October 28, 2015

SUBJECT: Comments on the Bay Delta Conservation Plan Partially Recirculated Draft Environmental Impact Report/Supplemental Draft Environmental Impact Statement

SUBJECT: Comments on the Bay Delta Conservation Plan and Environmental Impact Report/Environmental Impact Statement

Figure 24. Delta Outflow Change (Alt 4-ELT minus NAA-ELT)

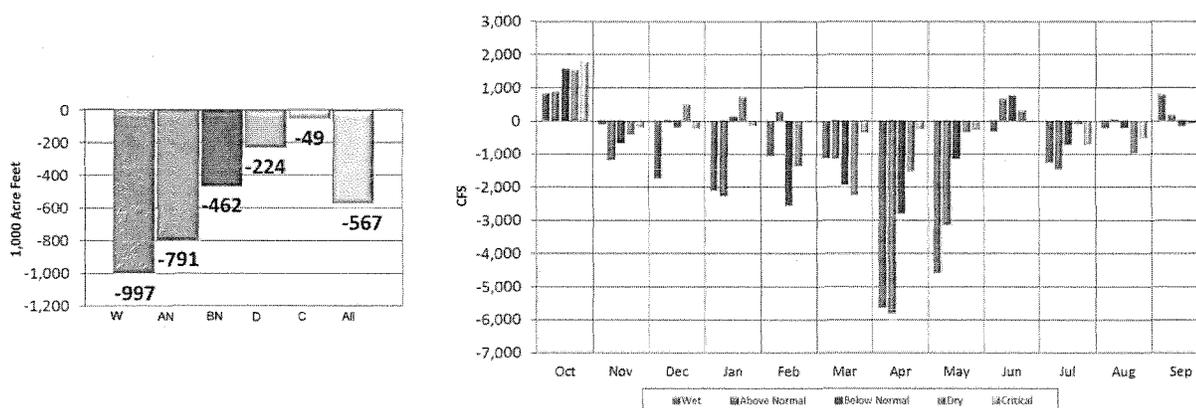
Figure 24 illustrates a comparison of Delta outflow between the NAA-ELT and Alt 4-ELT. Decreases in Delta outflow are the result of the CVP and SWP ability to increase Delta exports in Alt 4-ELT. The apparent increase in Delta outflow in October is partially due to additional export restrictions though Old and Middle River flow requirements. However, the increase in October Delta outflow is also due to an unrealistic operation of the Delta Cross Channel. The additional export restrictions cause the flow standards imposed at Rio Vista to be the controlling point in CVP and SWP operations; the water quality standards are all being met and do not require

flows above the amount needed to satisfy the Rio Vista standard. Meeting the Rio Vista flow standards without closing the Delta Cross Channel gate results in releasing more water from upstream reservoirs than would otherwise be necessary. This occurs because a certain amount of the water released to meet the Rio Vista flow standards would flow into the Central Delta at location of the Delta Cross Channel gate. This water would not make it to Rio Vista and therefore would not be counted towards meeting the Rio Vista flow standards. However, due to the BDCP model’s assumed restrictions on exports at this time, this water could not be pumped from the South Delta facilities and thus ends up as “extra” Delta outflow. By closing the Delta Cross Channel gate, the operators would assure that all of the water released to meet the Rio Vista flow standards would be counted towards those standards. The BDCP model’s assumptions that the Delta Cross Channel gate would not be closed are not practical or a sensible operation as the operators confirmed they would close the gate during these conditions to avoid the unnecessary loss of water supplies (as was done in October and November 2013). The assumption in the BDCP model to maintain the gate in the open position causes it to overstate the amount of Delta outflow.

Figure 44. Alt 4 North Delta Diversion Versus South Delta Diversion for July, August, and September

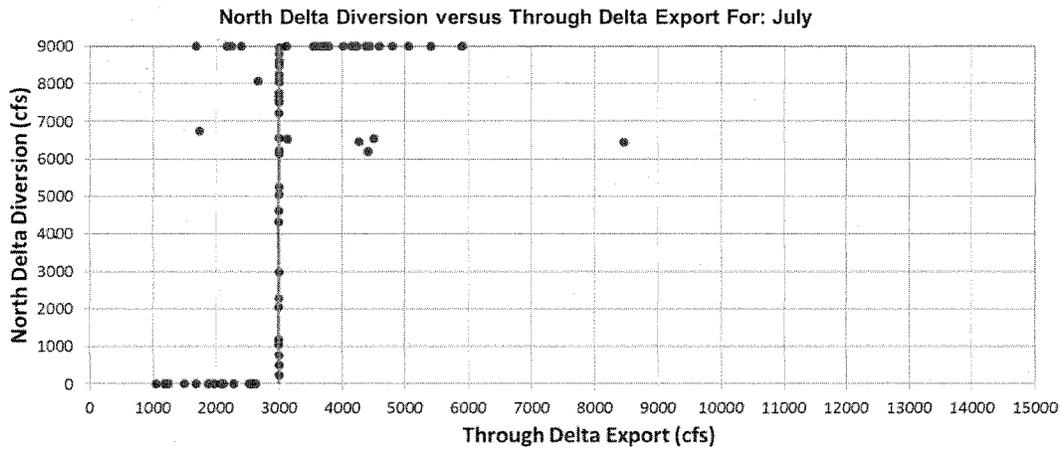
Figure 44 contains modeling results from Alt 4 for July, August, and September that plot NDD against SDD (Through Delta Export). There are many occasions when SDD are 3,000 cfs, which is due to criteria specifying that SDD during this time period need to be at least 3,000 cfs prior to diverting at the NDD facility. Although there are about six occurrences in July and three in August where the model did not satisfy this criterion, this issue has not yet been addressed for this modeling effort.

Figure 54. Result Difference: Delta Exports

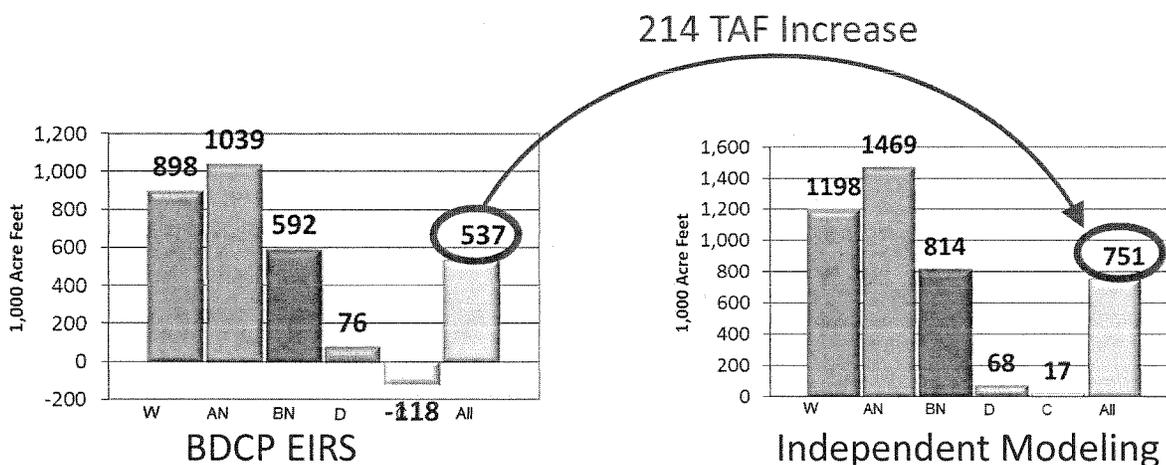
Figure 54 displays changes in the Delta exports for the BDCP modeling (Alt 4-ELT minus NAA-ELT) and for the independent modeling (Alt 4 minus FNA). Independent modeling analysis shows about 200 TAF greater increases in exports than the BDCP modeling. A large component of this difference is due to fixes of known modeling issues, as described in the 2013 SWP DRR. This difference is also attributable to more realistic reservoir operations, more efficient DCC gate operations, changes in water supply allocation logic, and more efficient operation of the NDD.

Figure 60. NDD, and Sacramento River Flow

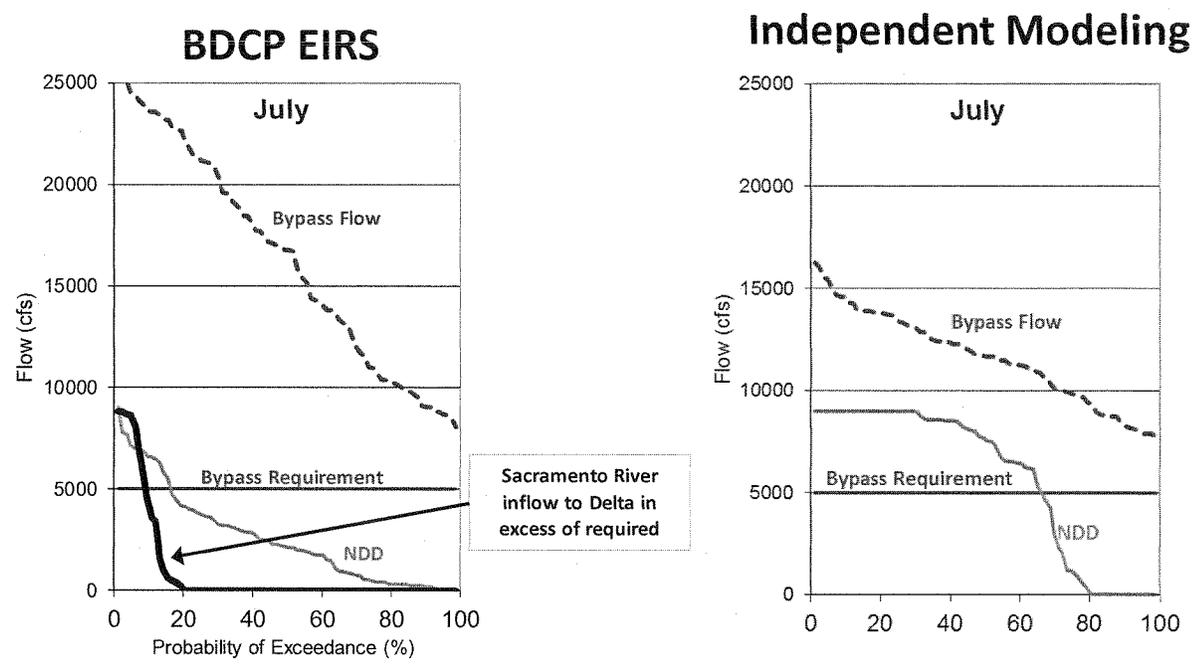
Independent modeling shows greater NDD during July and other months because the BDCP EIRS modeling includes artificially high Sacramento River bypass flow requirements. Figure 60 contains exceedance probability plots of Sacramento River required bypass, Sacramento River bypass flow, NDD, and excess Sacramento River flow to the Delta. As can be seen in Figure 60, bypass flow is always above the bypass requirement. The BDCP version of CalSim sets a requirement for Sacramento River inflow to the Delta that the independent modeling does not need in order to satisfy Delta requirements, therefore the NDD is higher in the independent modeling.

Figure 61. Sacramento River below Hood

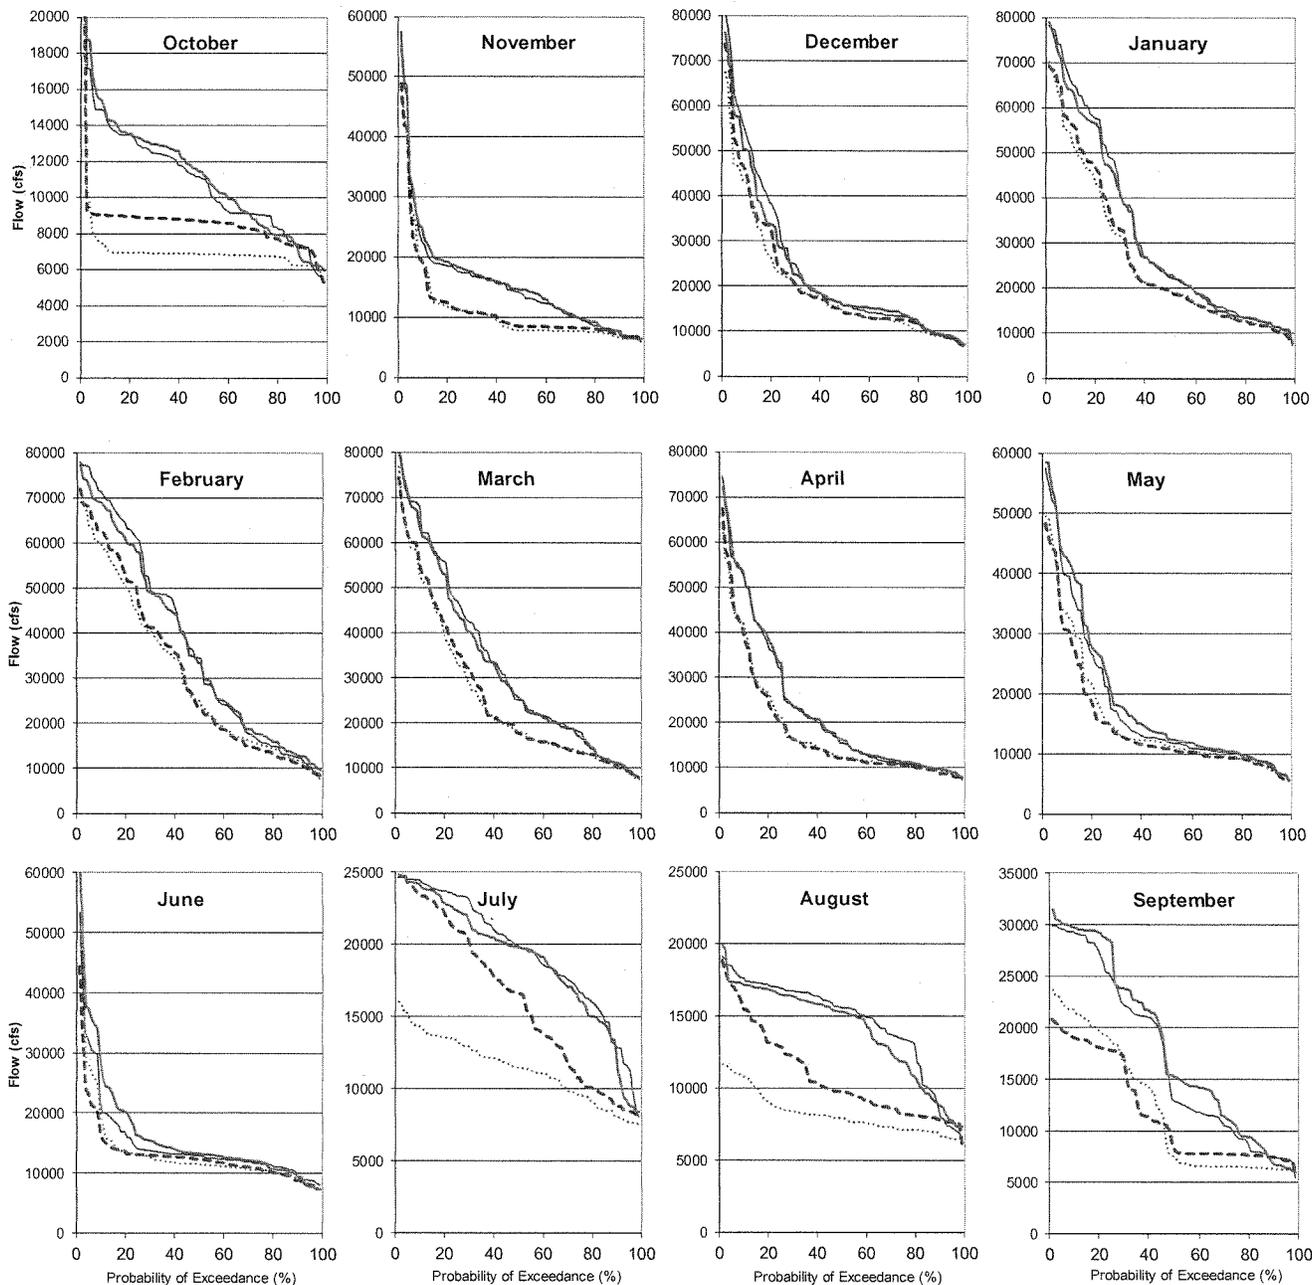
Figure 61 contains monthly exceedance probability plots for Sacramento River below the NDD for the following scenarios: 1) BDCP NAA-ELT, 2) BDCP Alt 4-ELT, 3) independent modeling FNA, and 4) independent modeling Alt 4. The most significant differences in flow changes occur in October, July, August, and September. Changes in Sacramento River flow entering the Delta are a key indicator of changes in interior Delta flows, water levels, and water quality.

In the independent modeling September flows are reduced by about 6,100 cfs while BDCP modeling shows a reduction of about 5,300 cfs. The independent modeling shows Sacramento River flow entering the Delta to be about 7,000 cfs 50% of the time, BDCP modeling show Sacramento River flow is about 8,000 cfs 50% of the time.

Figure 62. Flow through Delta Cross Channel and Georgianna Slough versus Sacramento River Flow at Hood

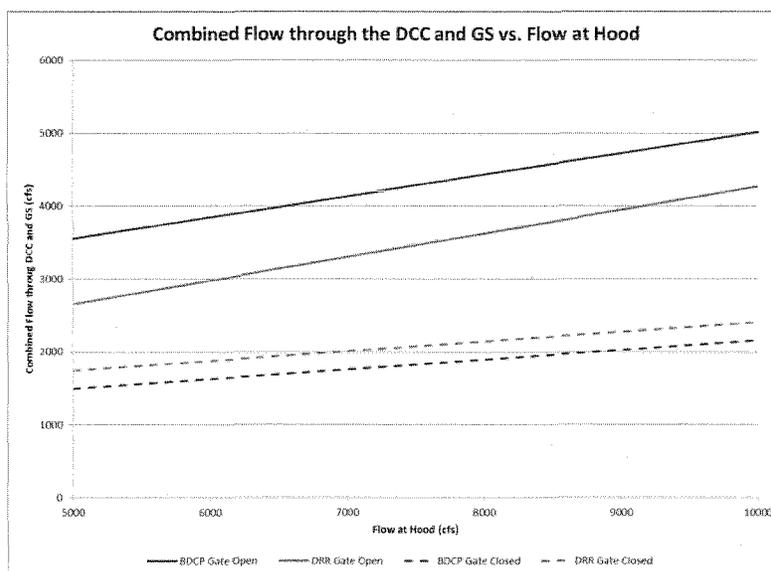
In CalSim, flow through the DCC gate and Georgianna Slough from the Sacramento River into the Central Delta is assumed to be linearly dependent on flow at Hood. There are two linear relationships; one is used when the DCC gates are closed, and the other is used when the DCC gates are open. The 2013 SWP Delivery Reliability Report CalSim II modeling, and therefore our independent modeling, used different linear flow relationships than BDCP. The BDCP and 2013 DRR (and independent) flow relationships for both the open and closed gate conditions are compared in Figure 62. When Sacramento River flow at Hood is in the range from 5,000 cfs to 10,000 cfs the balance between Hood flow, required flow at Rio Vista, and DCC gate operation can affect upstream reservoir operations, SOD exports, and Delta outflow. As shown in Figure 62, given the same flow at Hood and DCC gates closed, the independent analysis will show slightly higher flow into the Central Delta (12% to 17% difference for the Hood flows in the 5,000 cfs to 10,000 cfs range). With DCC gates open the same flow at Hood, the independent analysis will show lower flow into the Central Delta (-15% to -25% difference for the Hood 5,000 cfs to 10,000 cfs range). Figure 63 and Figure 64 show the differences through the DCC and combined flow through the DCC and Georgianna Slough.
